Rebuttal to Expert Evidence of Mr Hayden Burge – Landscape and Visual

(Tabled Document 119 – Proponent: White & Case LLP, 15 October 2025)

Submitted by: Darren and Julie Edwards

Location: Darley, Victoria

Figure 1: Conflict with Moorabool Planning Scheme Zones and Overlays

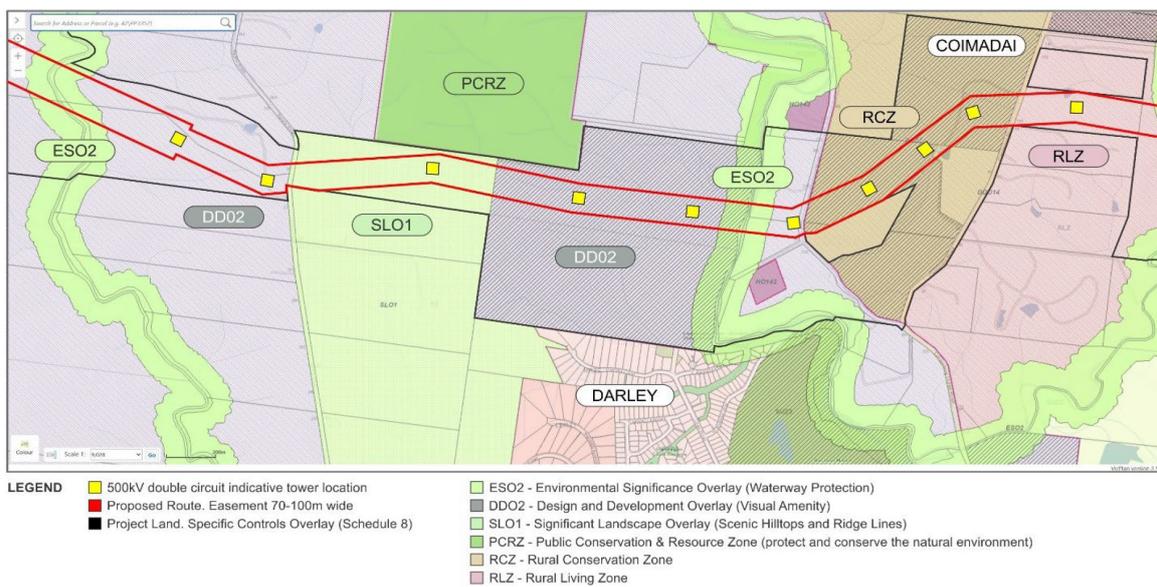
As shown in **Figure 1** below (from submission 216), the WRL alignment intersects multiple Moorabool Planning Scheme controls:

- **SLO1 – Significant Landscape Overlay (Scenic Hilltops and Ridgelines)**
- **DDO2 – Design and Development Overlay (Visual Amenity)**
- **ESO2 – Environmental Significance Overlay (Waterway Protection)**
- **RCZ – Rural Conservation Zone**
- **PCRZ – Public Conservation and Resource Zone** (State-significant Lerderderg State Park)

Tower locations:

- **One (1)** 500 kV double-circuit tower is located within the SLO1 area.
- **Four (4)** towers are located within the DDO2 overlay. All five of these structures adjoin the Lerderderg State Park (PCRZ), forming a continuous visual corridor across a landscape classified by the South West Victoria Landscape Assessment Study as **“Exceptional (State)”** significance.

This factual pattern contradicts Mr Burge’s claim that only *“one tower lies within SLO1”* and that landscape effects are “localised.” The overlays and zones collectively operate to protect the **setting and skyline of the State Park**, not only land within individual polygons.

Planning Instrument	Purpose / Objective	WRL Conflict as Demonstrated in Figure 1
Clause 42.03 – SLO1	Protect natural scenic qualities of hilltops and ridgelines; minimise visual impact of development.	Tower within SLO1 breaches objective by introducing dominant vertical structures on protected skyline.
Clause 43.02 – DDO2	Enhance visual amenity; ensure development respects rural landscape character.	Four towers within DDO2 disrupt rural landscape interface and visual amenity of Darley’s northern fringe.
Clause 42.01 – ESO2	Protect waterway corridors and adjacent vegetation.	Towers and easement cut across the Lerderderg River buffer zone, contrary to ESO2 objectives.
Clause 35.06 – RCZ	Conserve and enhance the character of open rural and scenic non-urban landscapes.	Construction of 80 m towers and 100 m easement contradicts the intent to retain non-urban character.
Clause 36.03 – PCRZ	Protect and conserve natural environments of State Parks and reserves.	Adjacent towers and conductors intrude on the visual envelope of the State-significant Lerderderg State Park.
